Addendum No. 3
INVITING SEALED BIDS ITB No. 21/10039
Project: West Campus Laboratories Bldg. F Renovation

Issue Date: February 24, 2021

Project:
Pima Community College
WEST CAMPUS LAB BUILDING F RENOVATION

ADDENDUM NO. 3
February 24, 2021

1 SECOND FLOOR ELECTRICAL POWER PLAN
SCALE: 1/8" = 1'-0"

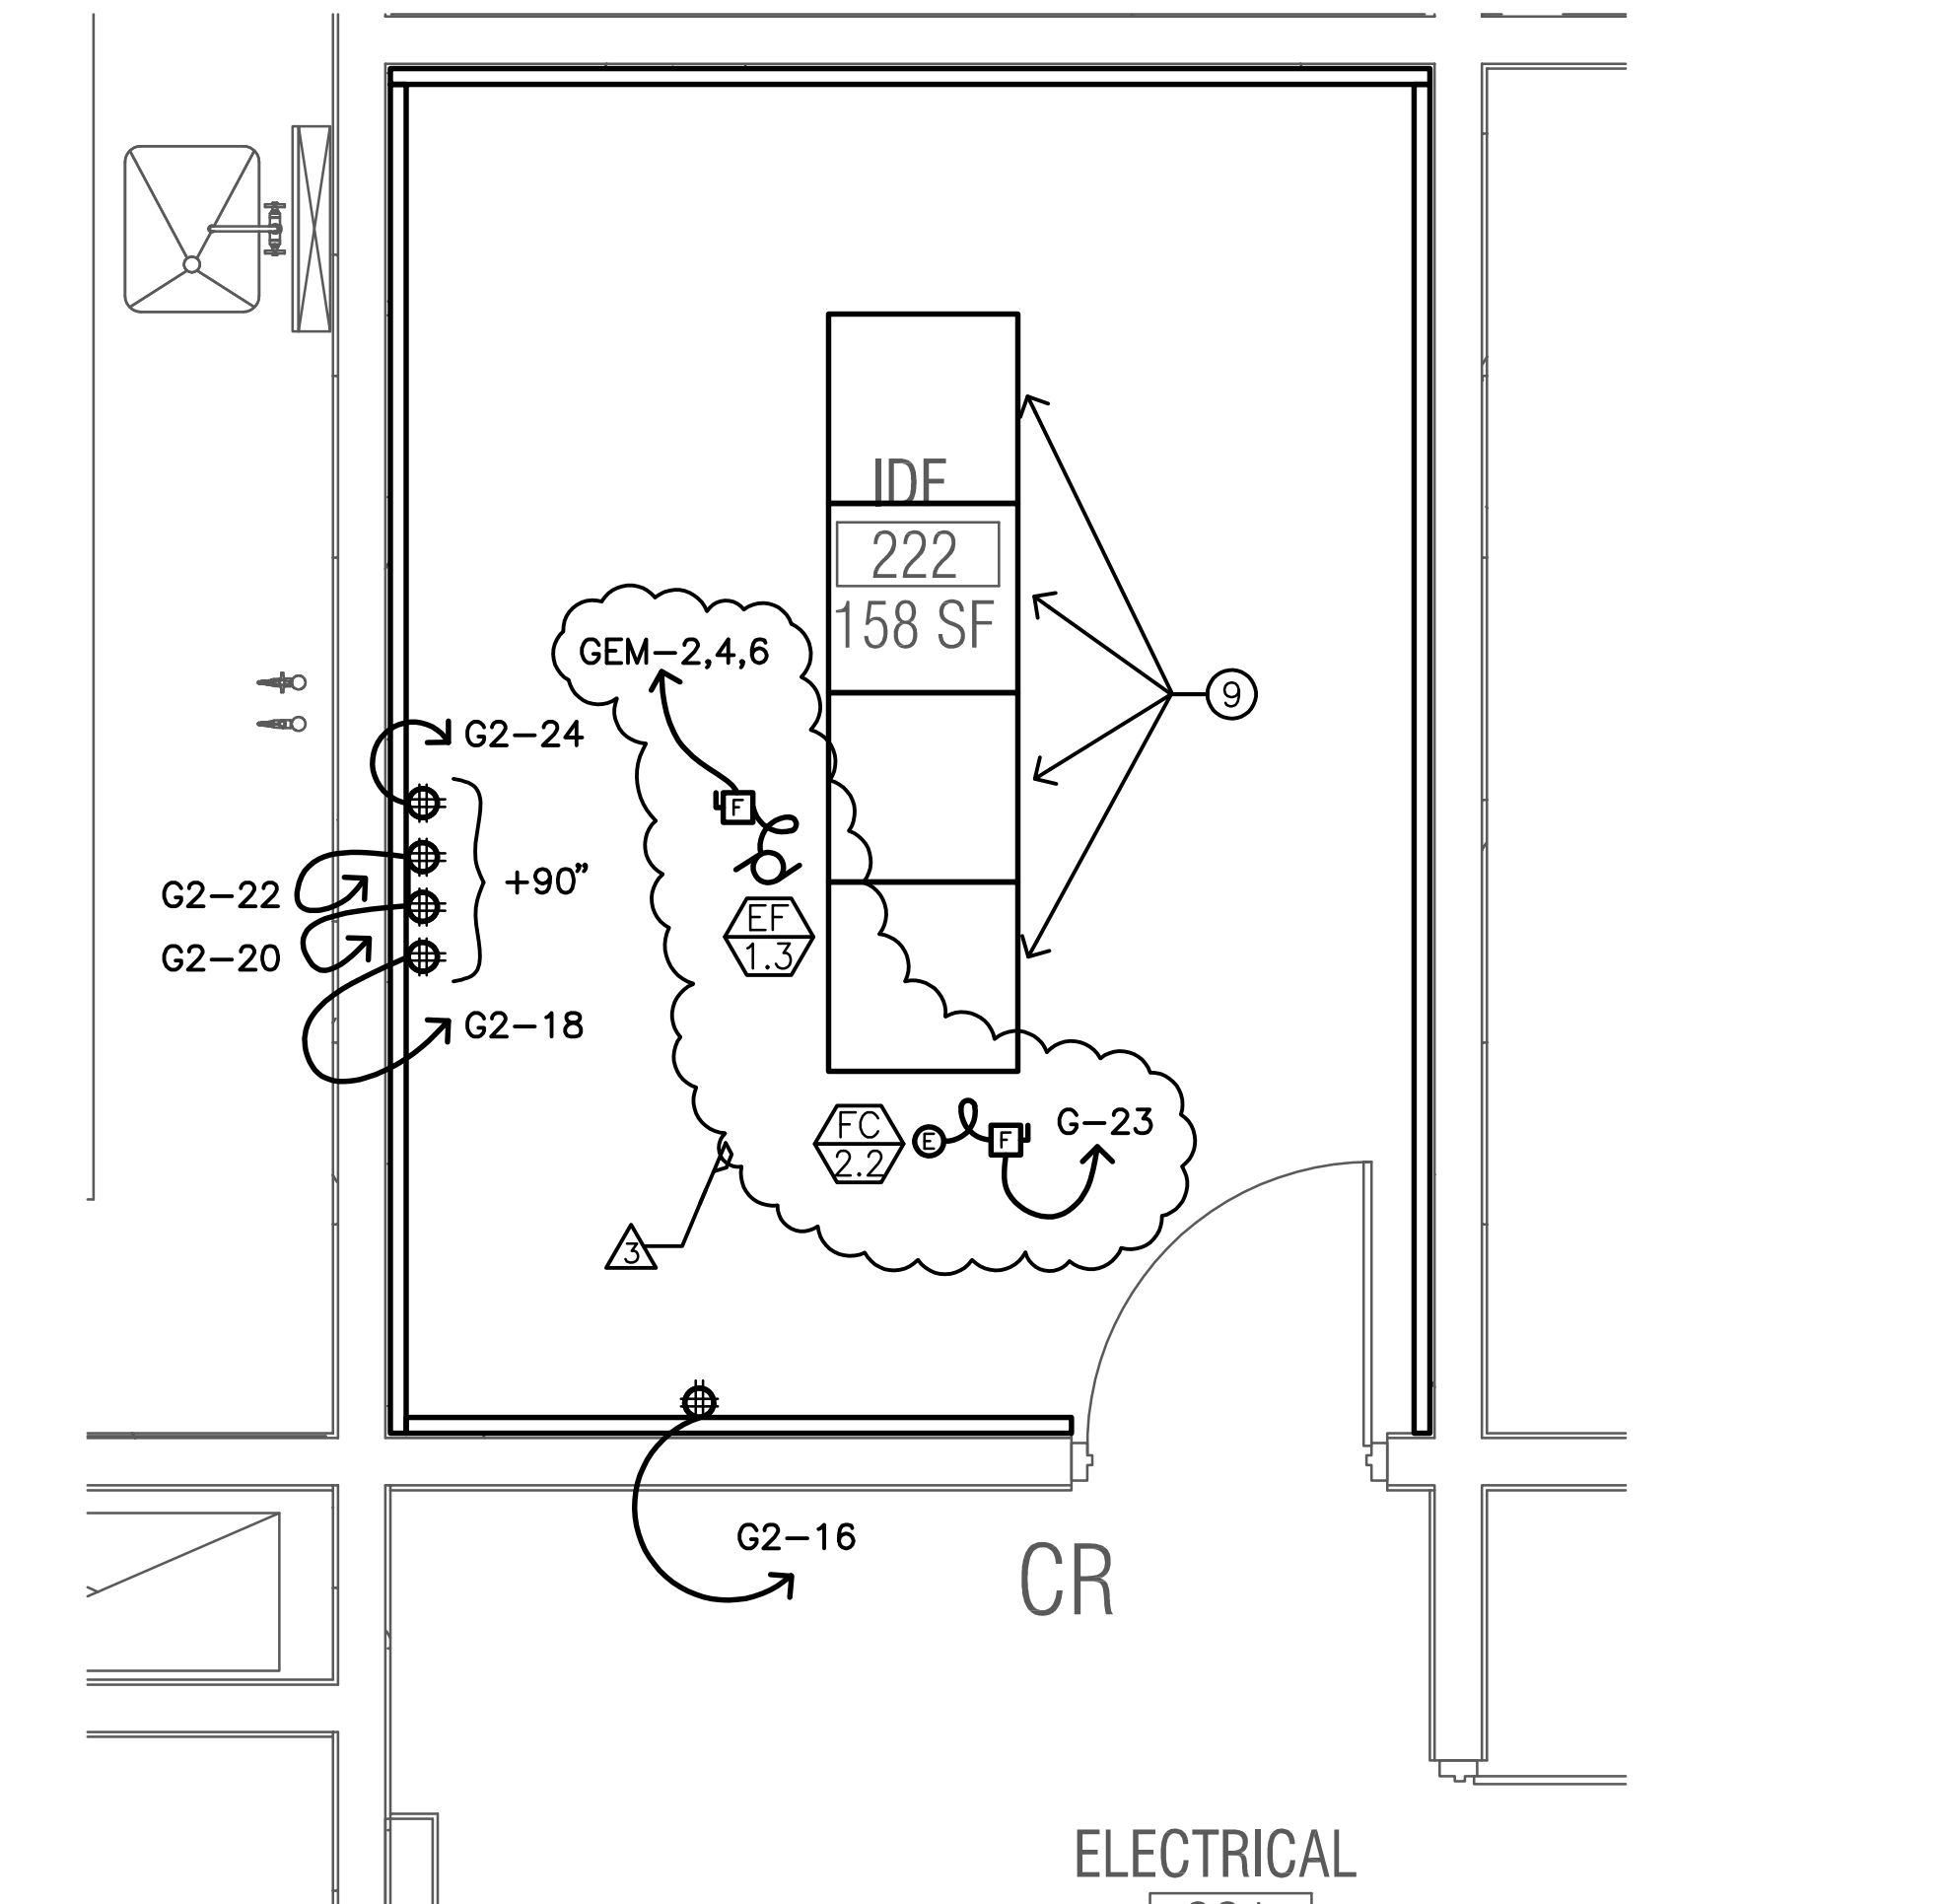
E2.20 ELECTRICAL SECOND FLOOR POWER PLAN
E5.0 ELECTRICAL PANEL SCHEDULES
E6.0 ONE-LINE DIAGRAM
